## Leaking Drain Plug on Gen III Cool Fuel Modules

MerCruiser engines with Gen III Cool Fuel modules supplied with drain plugs and falling within the following ranges:

43648

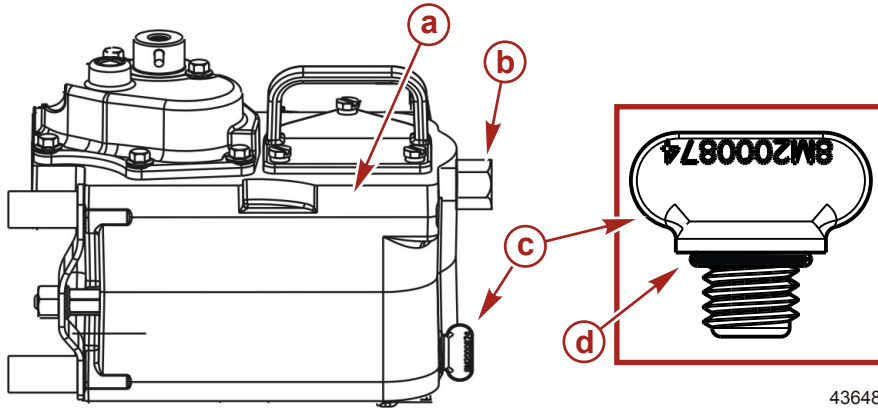
The blue drain plug must be firmly seated in the module housing and Perfect Seal should be applied to its threads. Failure to do so will allow salt water to seep in and damage the plug.

- Make sure that the sealing surfaces are clean and free of salt deposits.
- Verify that the new O-ring on the drain plug is not cut or damaged.
- Verify that the O-ring on the plug is 2.61 mm (0.103 in.) thick. If the O-ring is thinner, replace the O-ring.
- Verify that the drain plug threads are clean and free of deposits. If necessary, replace the plug (part number 806608A02).
- Verify that the threads of the fuel module housing are clean and free of deposits or corrosion. If necessary, clean the threads with a ½-13 tap; then apply sealant to the threads of the housing before installing the drain plug.

- Tighten the drain plug until the O-ring makes contact with the module housing; then rotate the drain plug another 180°.

If replacing a complete Gen III Cool Fuel system that will be used in salt water, apply Perfect Seal to the threads of the drain plug.
